STAFF REPORT

HEARING DATE: 4/20/2023

SUBJECT: H-2022-0087
 Noodles and Company at Ten Mile - CUP

Conditional Use Permit request for a new approximate 2,515 square foot quick-serve restaurant with a drive-through located within 300 feet of an existing drive-through facility on 0.623 acres of land in the C-G zoning district.

A. Site Plan

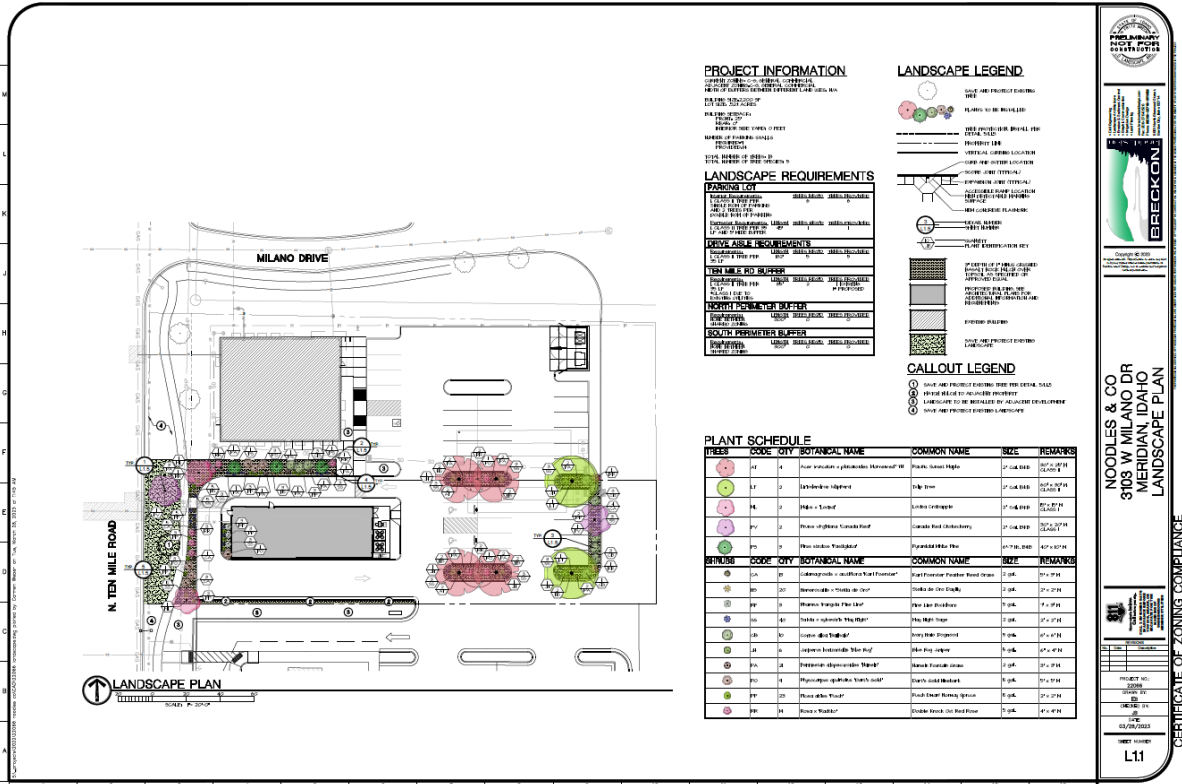
- b. Additional signage is required throughout the site to efficiently and adequately direct patrons to throughout the site with minimal conflict.
3. The site plan submitted with the future Certificate of Zoning Compliance application shall be revised as follows:

- a. The walkway from the perimeter sidewalk along Ten Mile Road to the main building entrance shall be distinguished from the vehicular driving surface through the use of pavers, colored or scored concrete, or bricks as set forth in UDC [11-3A-19B.4b](#).

- b. Revise the site plan to include a revised detail of the bike rack that meets the requirements of [11-3C-5C](#) with the future Certificate of Zoning Compliance (CZC) Application.

- c. Applicant shall work with Republic Services to establish an adequate quantity of trash and recycle bins to service this site prior to submittal of the CZC Application (site plan depicts sharing on-site trash with property to the north).

- d. All mechanical equipment on the back of the building and outdoor service and equipment areas should be incorporated into the overall design of buildings and landscaping so that the visual and acoustic impacts of these functions are fully contained and out of view from adjacent properties and public streets as set forth in UDC [11-3A-12](#).

- e. Depict signage ahead of each pedestrian crossing(s) in the drive-through lane (south) notifying drivers to watch out for pedestrians.
4. The landscape plan submitted with the future Certificate of Zoning Compliance application shall be revised as follows:

B. Landscape Plan (dated: 10/14/2022)

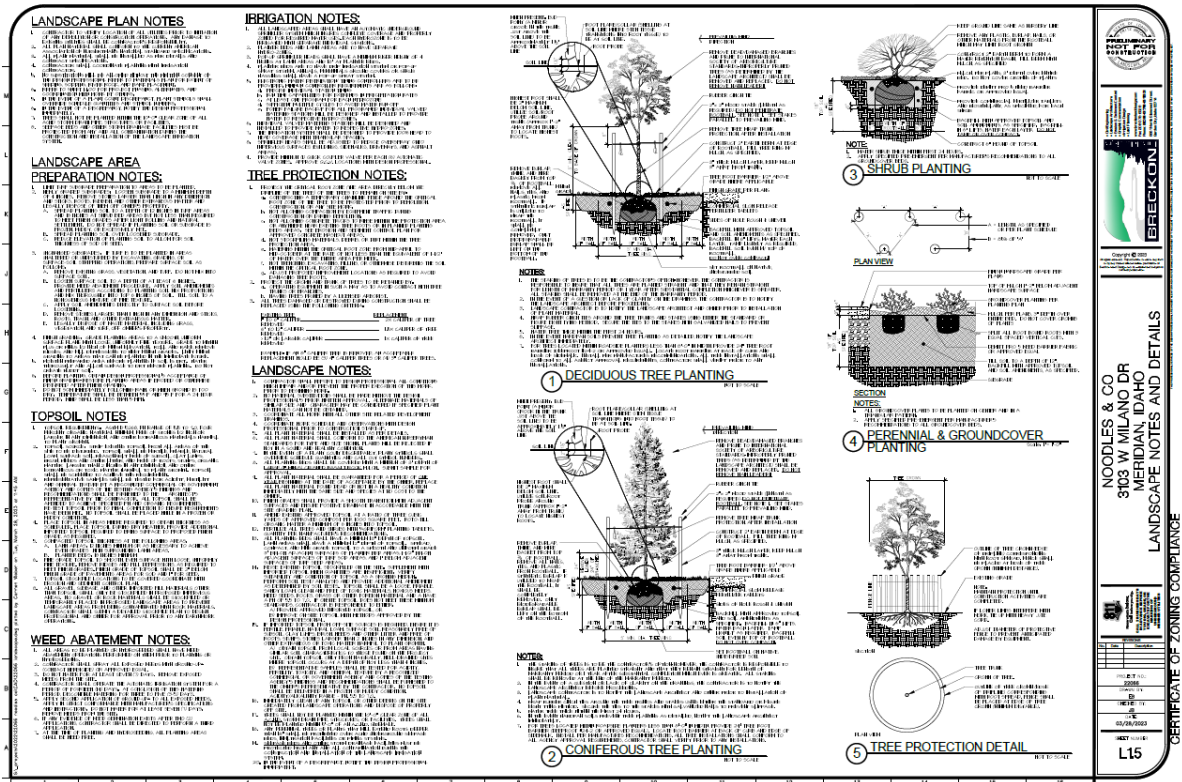
In addition, a minimum 5-foot wide landscape buffer is required to be provided along the perimeter of the parking or other vehicular use areas as set forth in UDC 11-3B-8C.1. The submitted landscape plan shows the required perimeter buffers along the north, east, and west boundaries. The Applicant is proposing a 2-foot perimeter landscape buffer along the drive aisle on the south side of the property line. Per UDC 11-3B-8C.1, this requirement may be reduced or waived at the determination of the Director where there is a shared driveway and/or recorded cross-parking agreement and easement with an adjacent property.

Alternative Compliance (ALT) to the perimeter landscape buffer standards is requested due to the limitations of the narrow lot space. The Applicant has re-designed their site in an effort to retain the pick-up window and included the properties to the north to demonstrate how they integrate with

- a. The walkway from the perimeter sidewalk along Ten Mile Road to the main building entrance shall be distinguished from the vehicular driving surface through the use of pavers, colored or scored concrete, or bricks as set forth in UDC [11-3A-19B.4b](#).

- b. Ensure compliance with UDC 11-3B-5 for all landscaped areas and comply with the parking lot landscaping standards in accord with UDC 11-3B-8C.
 - c. Existing landscaping shall be protected during construction in accord with UDC 11-3B-10C.3.

each other. In regards to the landscape buffer separation with the Bank, the Applicant is adding an additional 2-feet of landscaping on the Noodles side of the property line. This allows the drive aisle to remain 25-feet wide along the southern boundary to accommodate the required escape lane. The perimeter landscape buffer between Noodles and the Bank will result in a 10-foot wide buffer (8-feet on the Banks side, and 2-feet on the Noodles side) meeting the intent of the code. The Applicant is proposing additional shrubs in the landscape buffers along the north and west sides of the site. Based on the analysis, the Director is supportive of the request for ALT for the proposed 2-foot perimeter landscaper buffer along the southern boundary of the Noodles site.

C. Conceptual Building Elevations

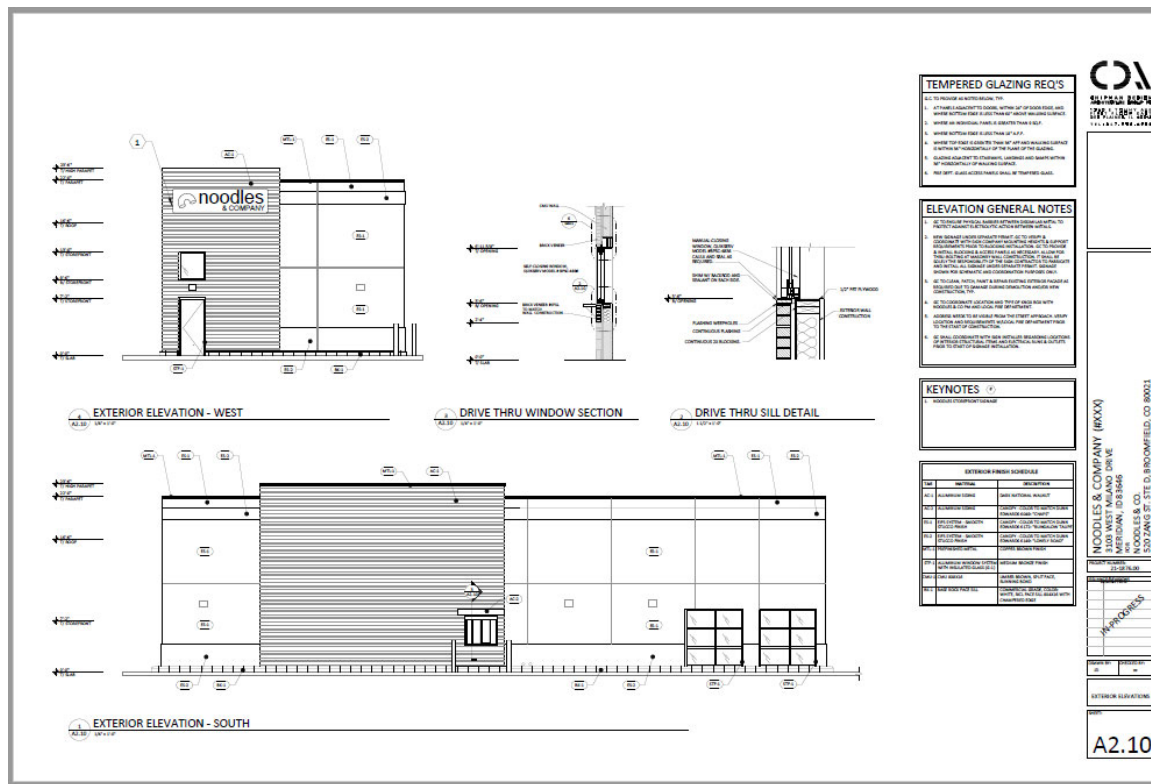
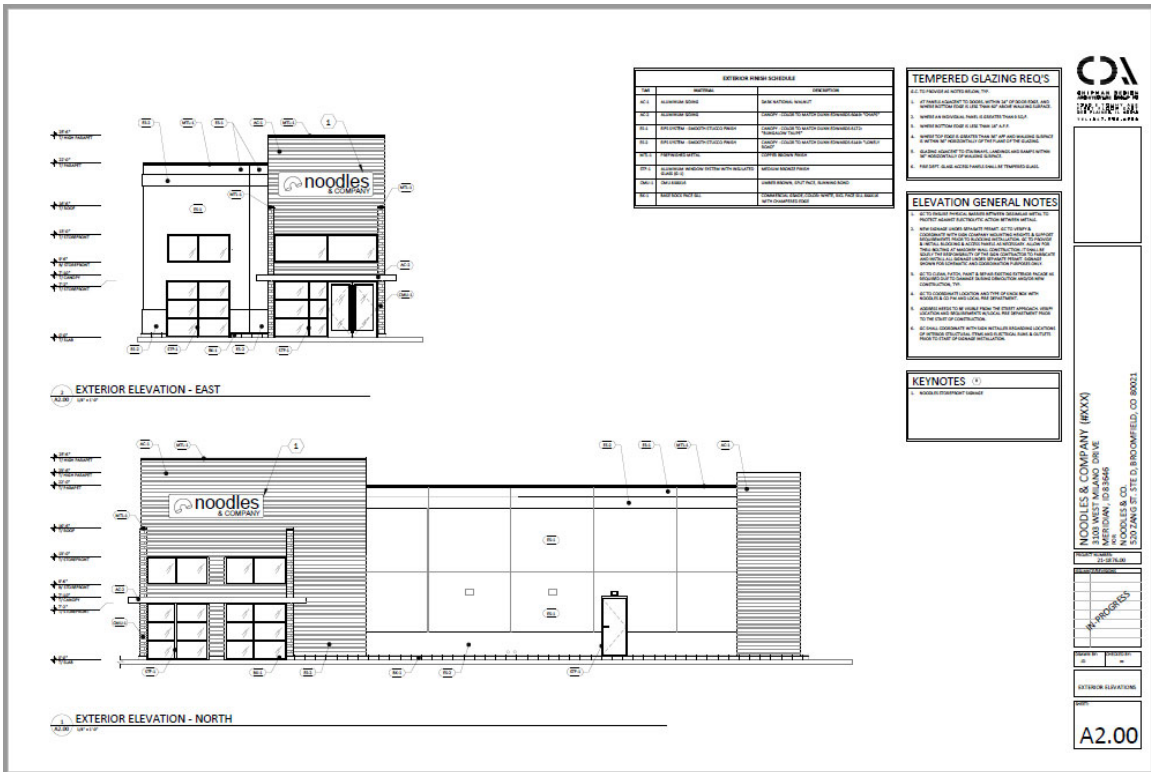
Building Elevations: The Applicant submitted conceptual building elevations for the proposed restaurant with drive-through. The building elevations depict aluminum siding (dark national walnut/chaps in Dunn Edwards), EIFS smooth stucco finish with expansion joints (bungalow taupe/lonely road in Dunn Edwards), CMU brick (umber brown), stone/rock veneer (brownstone), and aluminum window system (medium bronze finish). *The final design of the structure is required to comply with the design standards listed in the Architectural Standards Manual.*
